AL BASRAH OIL TERMINAL  
BASRAH, IRAQ

**SIGIR PA-06-080**  
**APRIL 26, 2007**

SUBJECT: Report on the Al Basrah Oil Terminal, Basrah, Iraq (Report Number  
SIGIR PA-06-090)

## Al Basrah Oil Terminal, Basrah, Iraq

Figure 9. Original number and location of motorized lifeboats and life rafts on ABOT

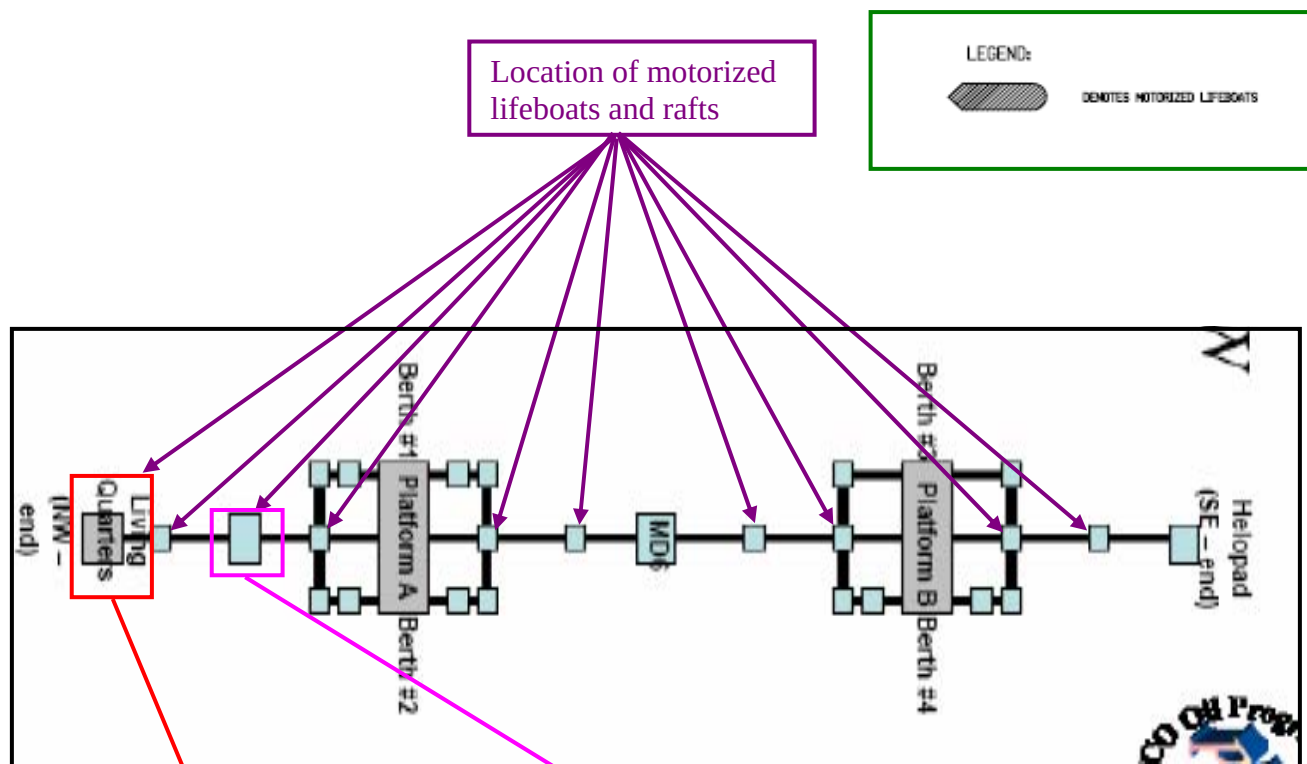
The original estimated cost for the project was approximately \$1.8 million. Figures 9, 10, and 11 show the number and location of the lifeboats and life rafts.

In May 2006, a revised SOW deleted the requirement for motorized lifeboats and reduced the project amount to \$425,188. GRD Oil representatives stated the requirement for motorized lifeboats was de-scoped due to funding limitations. A 13 June 2006 GRD briefing chart stated the new SOW required the contractor to “replace four existing lifeboats with fifteen 16-person capacity life rafts with cradles...Design and install the life raft deployment system.” However, on 22 May 2006, PIJV placed an order with the supplier for only eight life rafts.

Figure 15. Illustration of a fully inflated life raft (note life raft does not appear to hold 20 occupants)

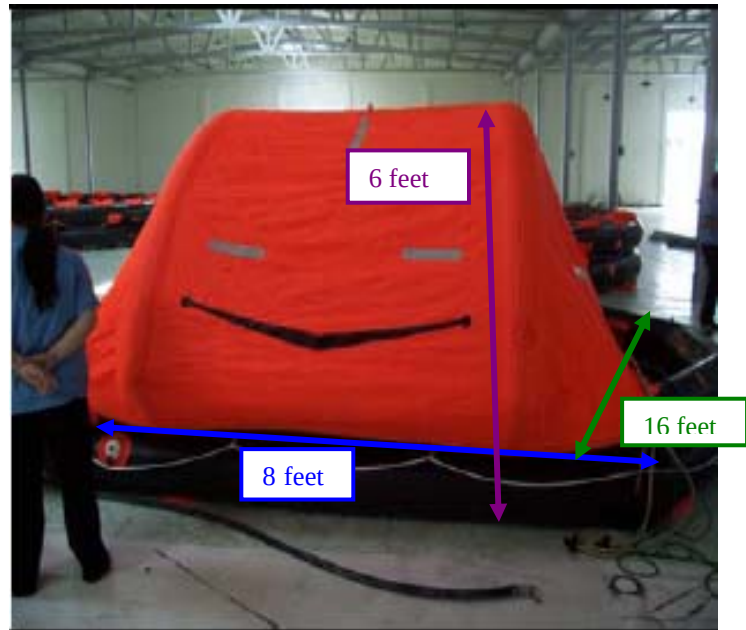
The information provided by the manufacturer did not include a photograph of the entire life raft, instead relying solely upon an illustration (Figure 15). The only photographs available of the life raft were provided by the company that inspected the life rafts. However, full length views of the front and rear of the life raft were not provided; instead only various angles of the life raft were available. Site Photos 22 and 23 provide an interior and exterior view of the life raft, respectively.

GRD representatives have stated the "the life rafts are totally enclosed," which complies with PIJV's specification that the "life raft shall have a canopy to protect the occupants from exposure..." The life raft chosen is not completely enclosed (Site Photos 24 and 25) and will not provide the occupants any protection from a major fire. In addition, GRD representatives stated that the life rafts are a "covered type design that would protect life raft from waves during heavy seas." According to GRD representatives, sea waves of approximately 15 feet are not uncommon for the ABOT area. We have concerns that this particular life raft, which is not fully enclosed and made of a soft skin cover, would survive long in such sea conditions.

**Figure 16. Current location of the two existing evacuation escape capsules and eight life rafts**

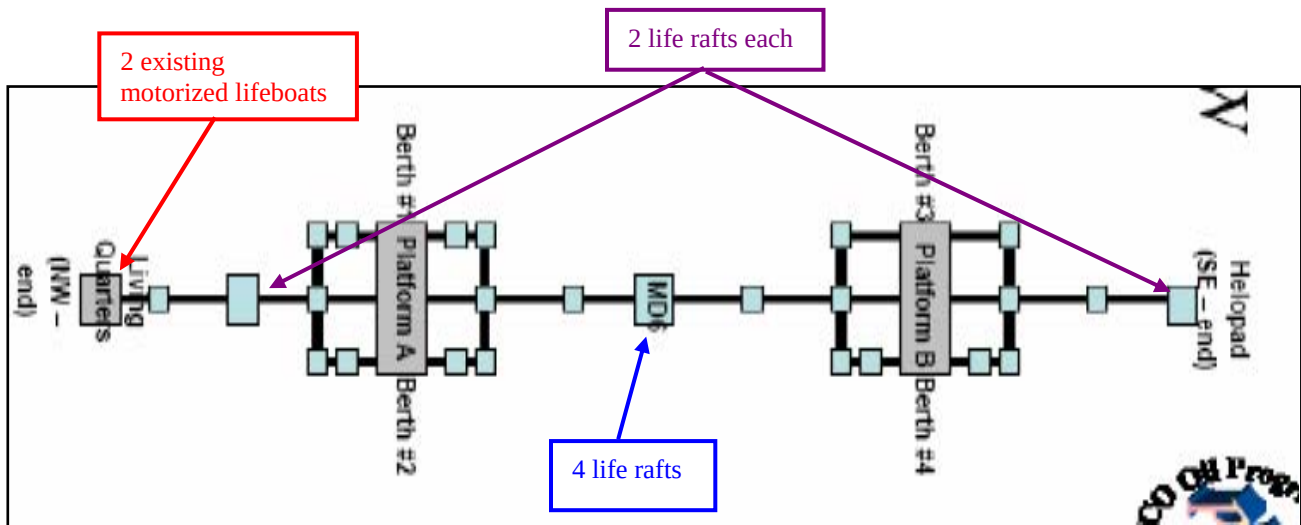
According to GRD representatives, the eight life rafts were installed at the helipad, MD6, and MD2 (Figure 16). Currently, there are no known muster points for an emergency evacuation on ABOT; therefore, we cannot determine if the life rafts were installed at the correct spots.
